City of Alexandria, Virginia

MEMORANDUM

SUBJECT: WORK SESSION COMMENTS ON 220 SOUTH UNION STREET
BAR CASE #2014-0037 and 2013-0321

view looking east on Duke Street
at lee Street

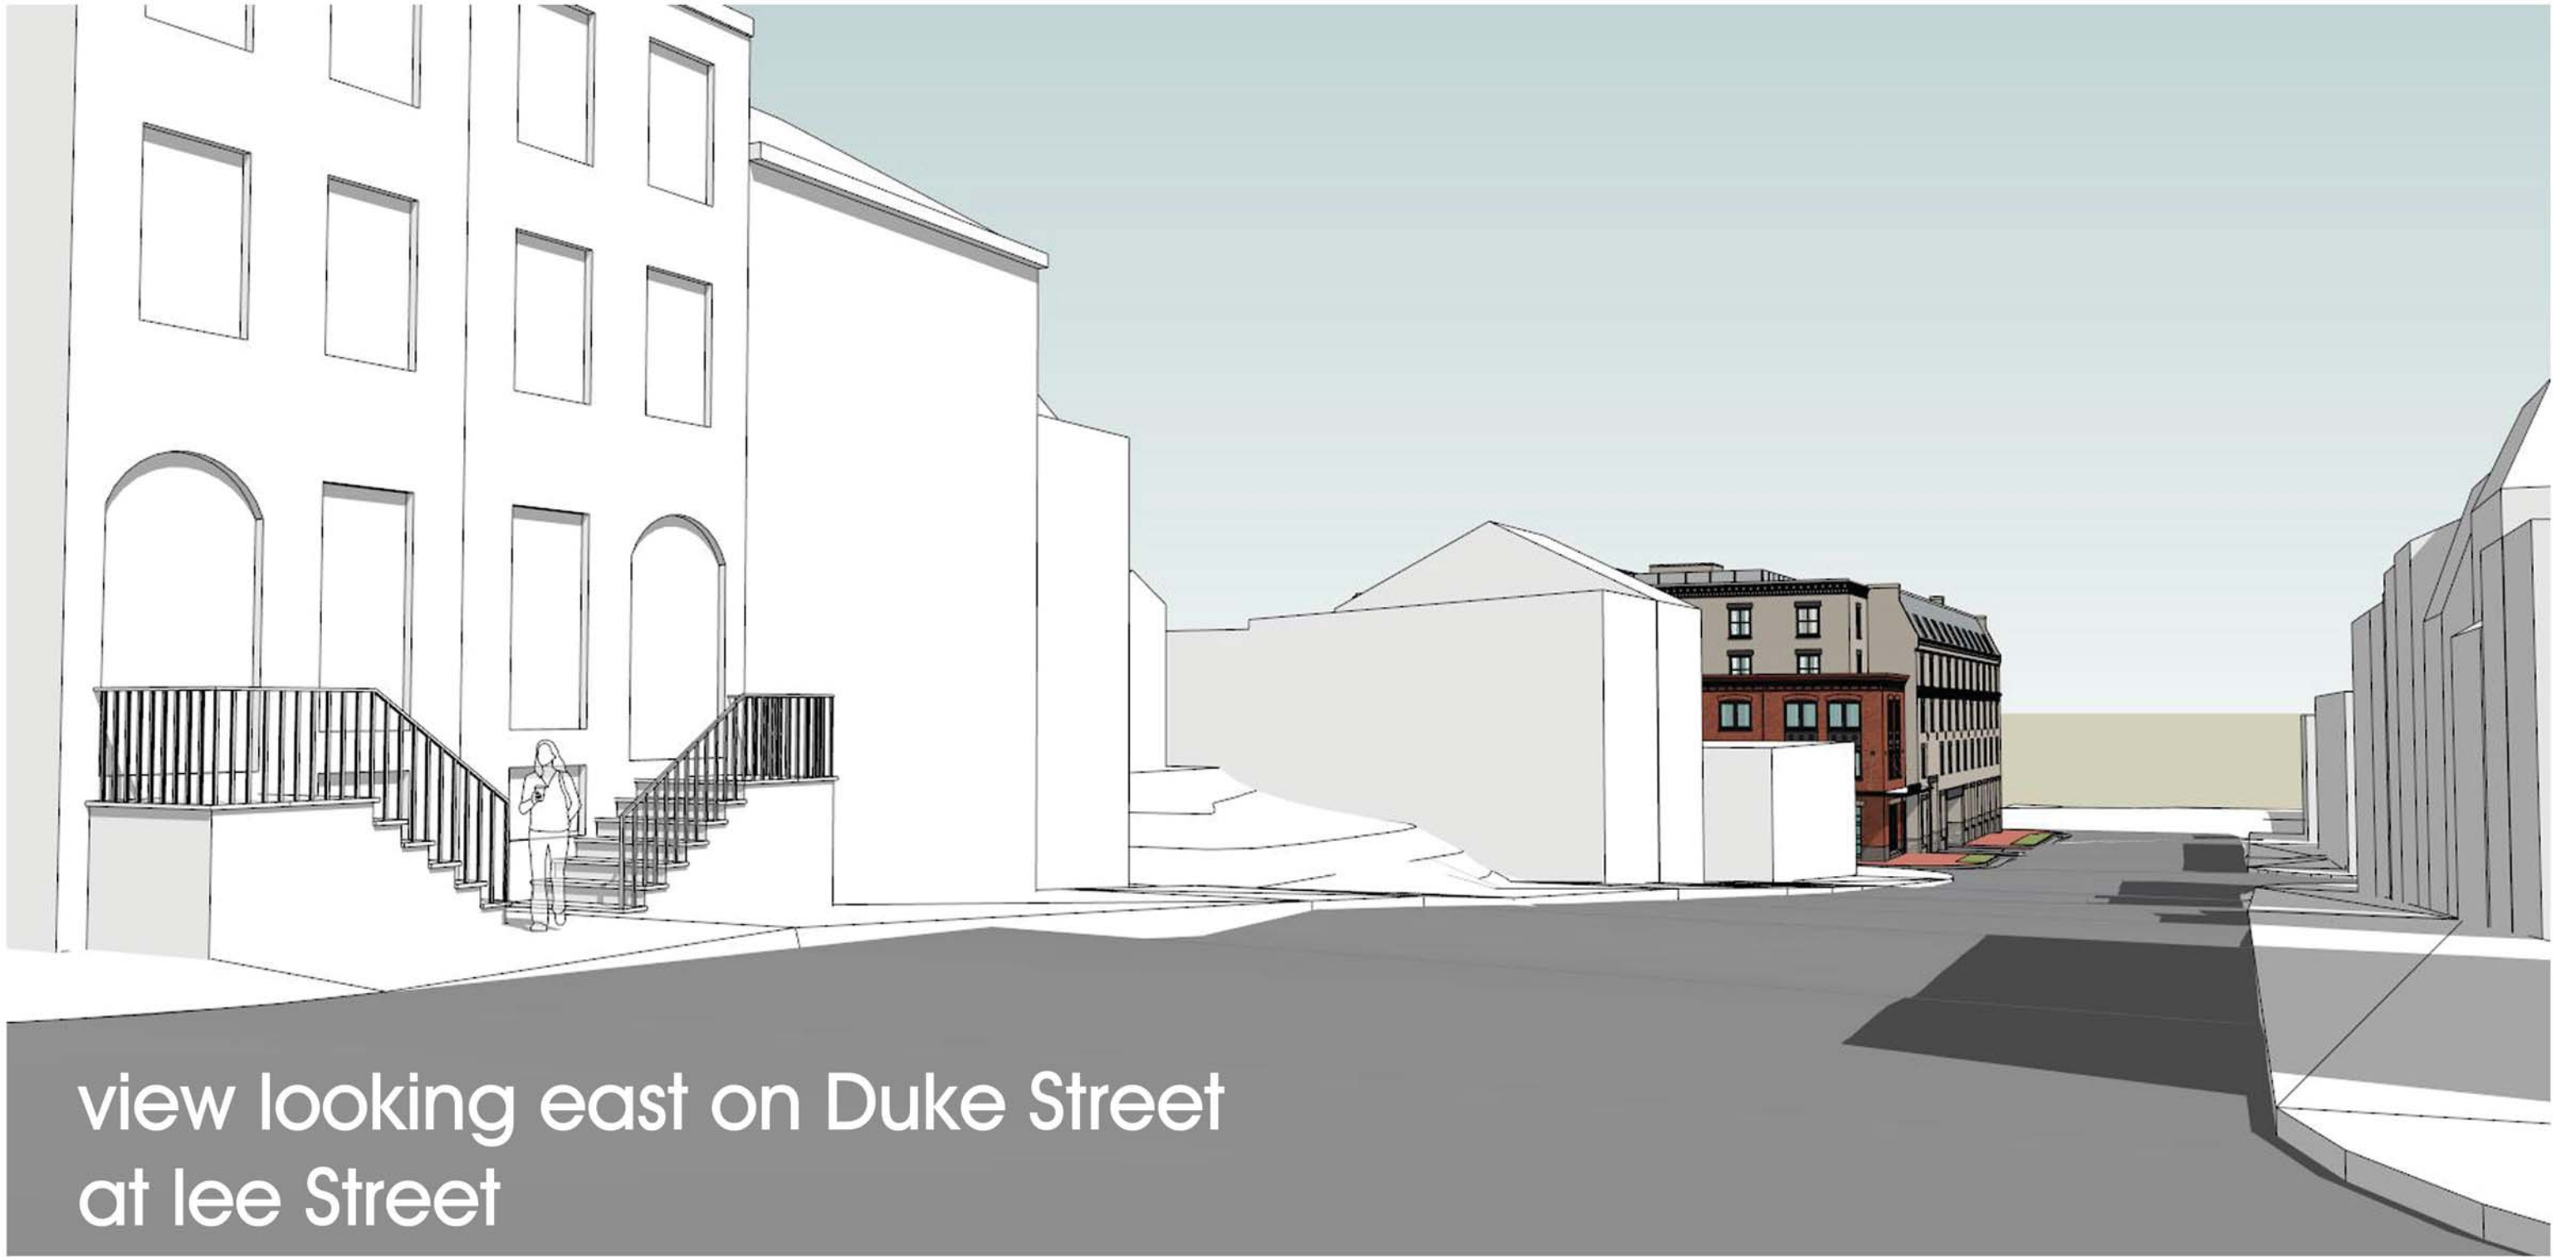
The applicant has provided perspectives showing that the recommended west gable end would only be minimally visible to pedestrians from the Duke and Lee Street intersection a block away and may not read coherently with the rest of that portion of the building. However, the rooftop mechanical equipment still must be screened with material that is equal in quality to the building

wall. The applicant has, therefore, suggested, and staff supports, extending the brick wall of the elevator penthouse. The applicant has also represented that the rooftop equipment has been gathered in the center of the roof and will not be visible to pedestrians from any other locations. The Board may, therefore, consider waiving the rooftop mechanical equipment screening. The gable on the Strand elevation will be functional screening and the framing behind that roof will be further studied by the applicant.

suggested additional gable location

western "gable end"
not visible from courtyard because of
elevator penthouse

if provided, gable is 21' - 6" from face of 5 story
facade.

add matching gable end to west side of building #2

Current Recommendation: That the Board evaluate the option of an expanded elevator penthouse as rooftop mechanical screening and the potential for waiving a portion of the rooftop mechanical screening at the work session.

4B

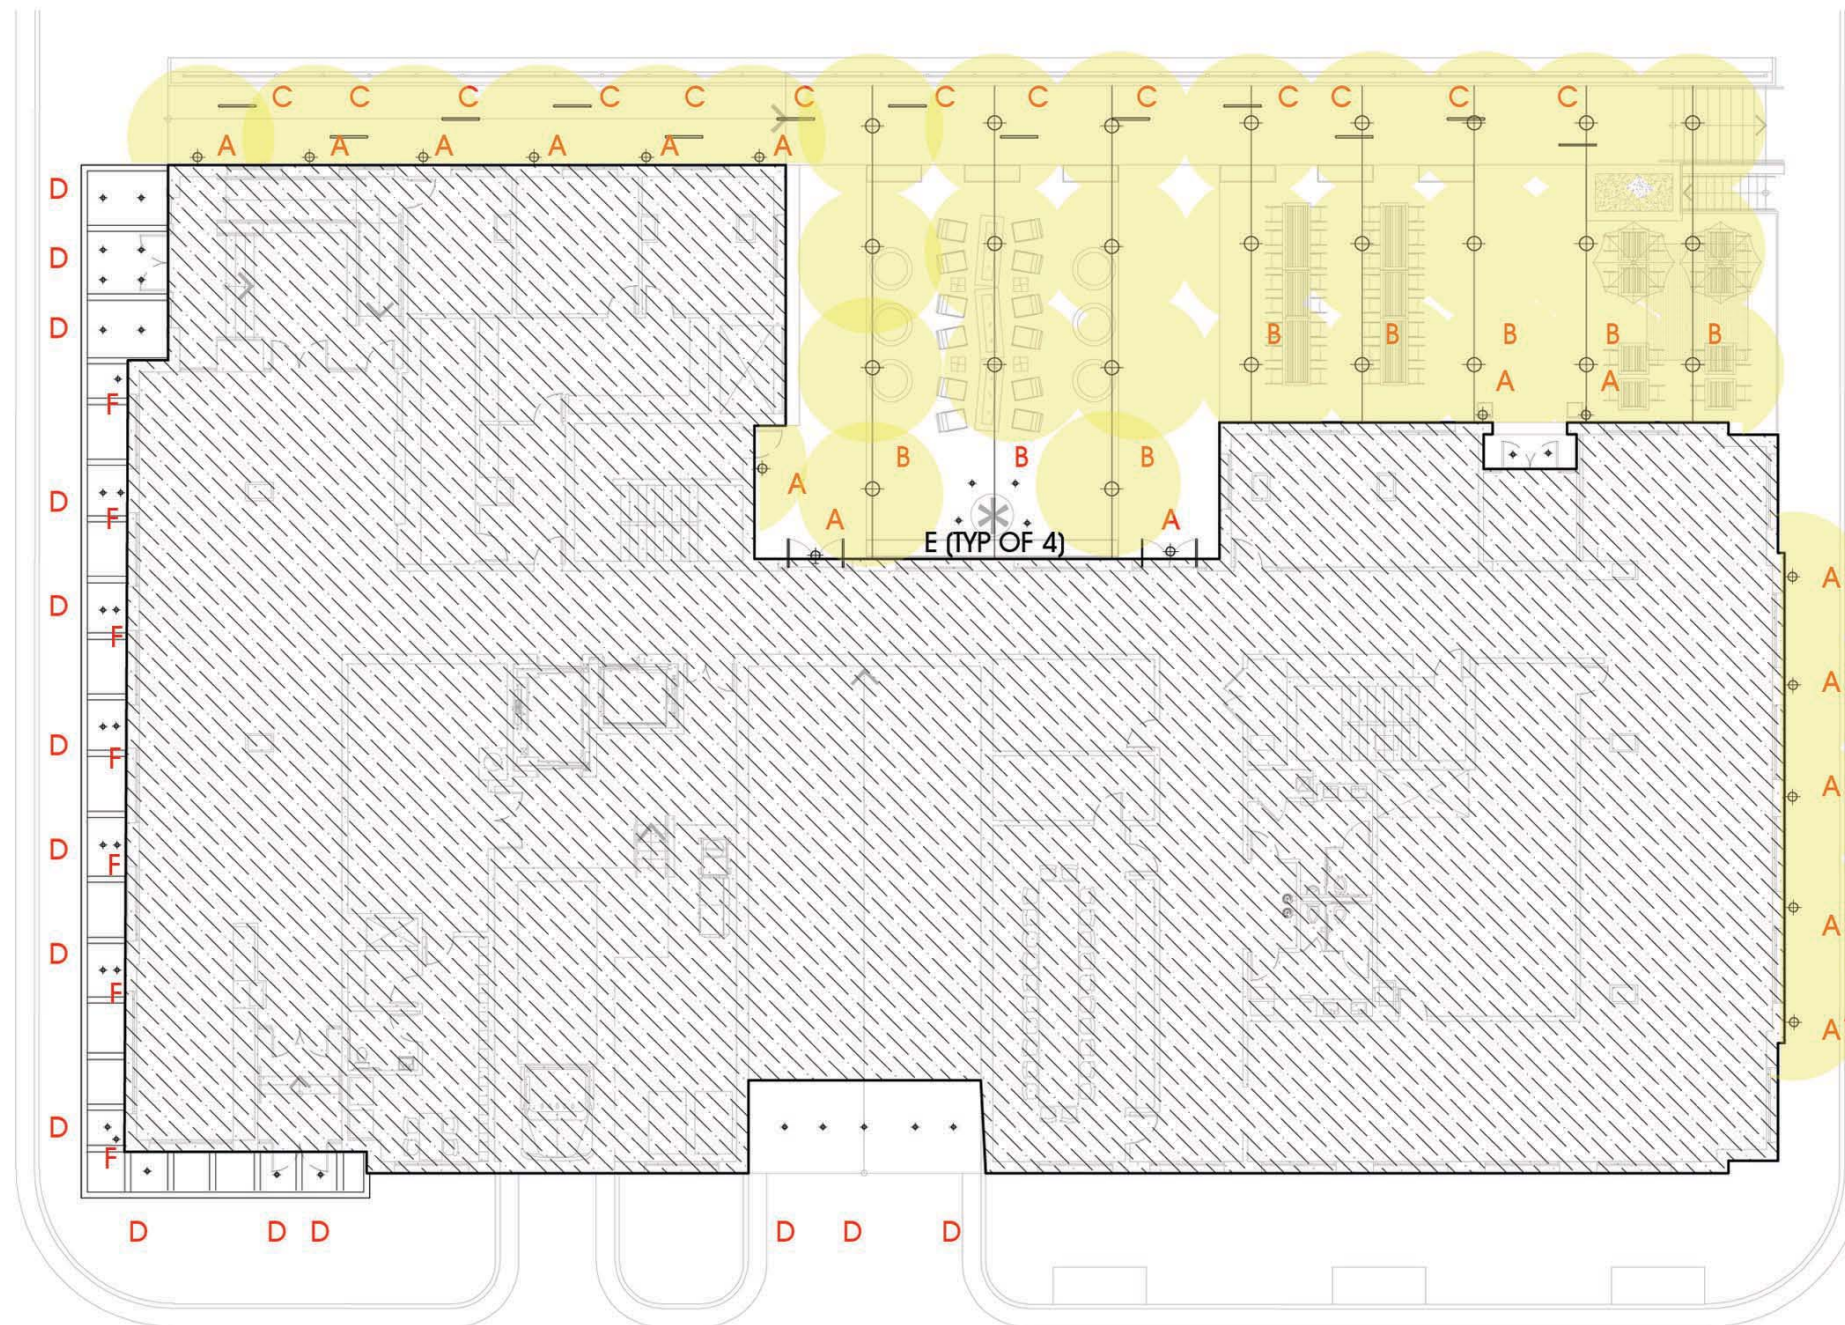
The applicant has submitted a preliminary site and architectural lighting plan. Full specifications of the various fixtures will be submitted in the future.

Current Recommendation: Return to BAR at a later date for comprehensive sign plan and light fixture selection.
